May 24, 2013

Peach Bottom Atomic Power Station, Units 2 and 3  
Facility Operating License Nos. DPR-44 and DPR-56  
NRC Docket Nos. 50-277 and 50-278

Subject: Extended Power Uprate License Amendment Request – Supplement 3  
Response to Request for Additional Information - Extended Power Uprate

A sketch is provided to show the conceptual design for the HPSW Transfer Switch.

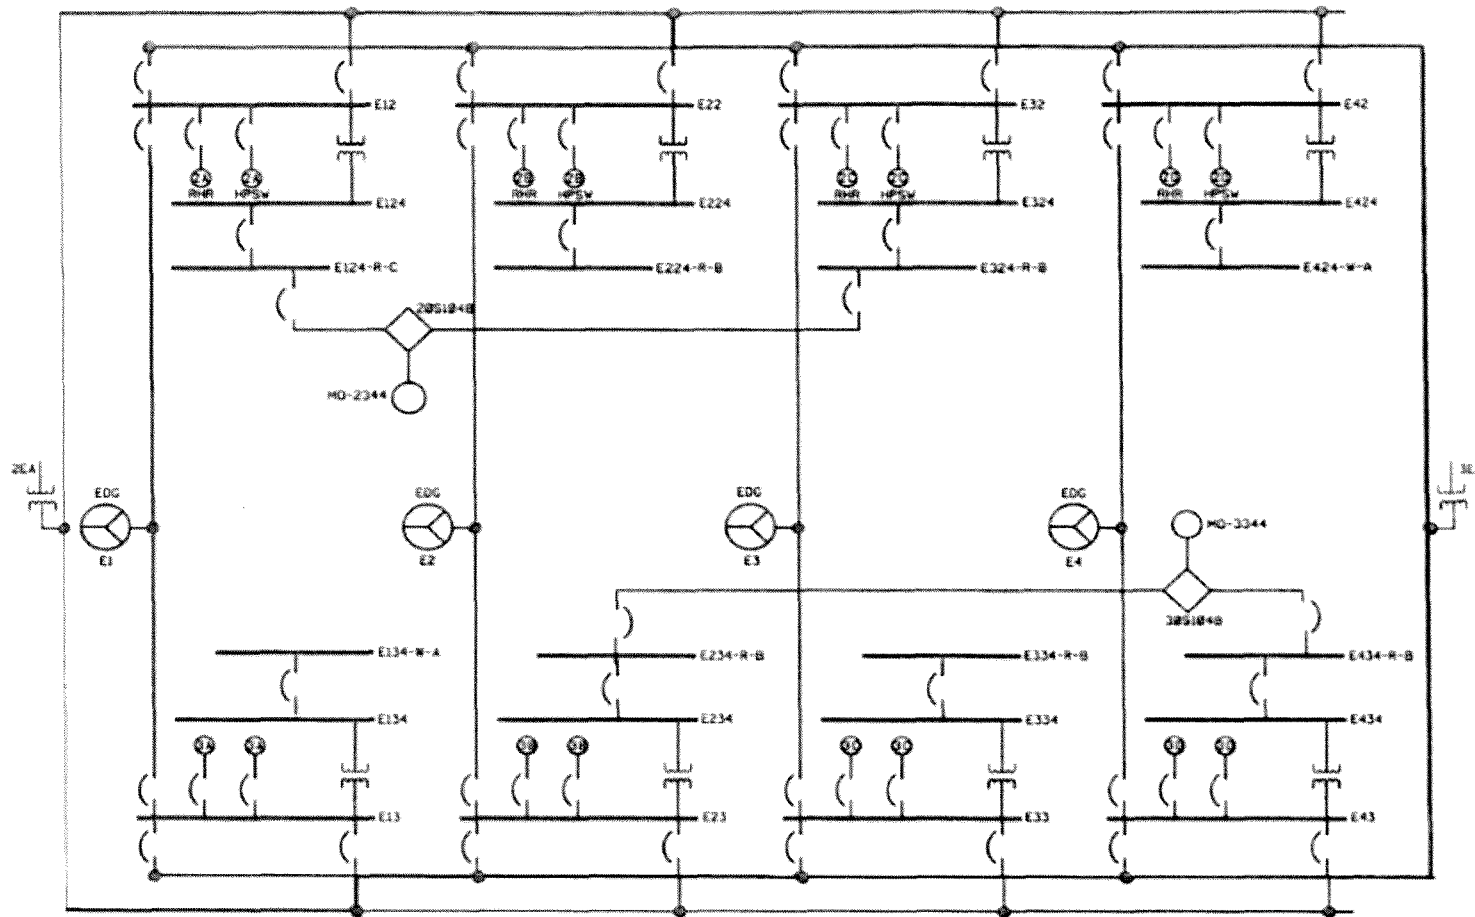
On page 2-224 of Attachment 4 to the application dated September 28, 2012, the licensee states that an additional High-Pressure Service Water (HPSW) pump motor and Residual Heat Removal heat exchange cross-tie modifications will be needed due to the EPU. Provide a brief description of these modifications and its impact on the electric system. Provide the current licensed thermal power (CLTP) and EPU loading (kW), and continuous rating of the emergency diesel generators in light of these modifications. Also provide an electrical diagram that shows the additional HPSW pump and the cross-tie modifications.

As discussed during the NRC-EGC clarification call on 4/19/13, Peach Bottom is not adding a new HPSW Pump motor – the line item was intended to indicate that a modification to support starting an additional HPSW pump motor and a modification to provide a Residual Heat Removal heat exchanger cross-tie are required to support EPU. Modification details are provided in Enclosure 9C (RHR HX Cross-Tie Modification) Section 4.0 (Scope of Modification) and 9D (HPSW Cross-tie Modification) Section 4.0 (Scope of Modification).
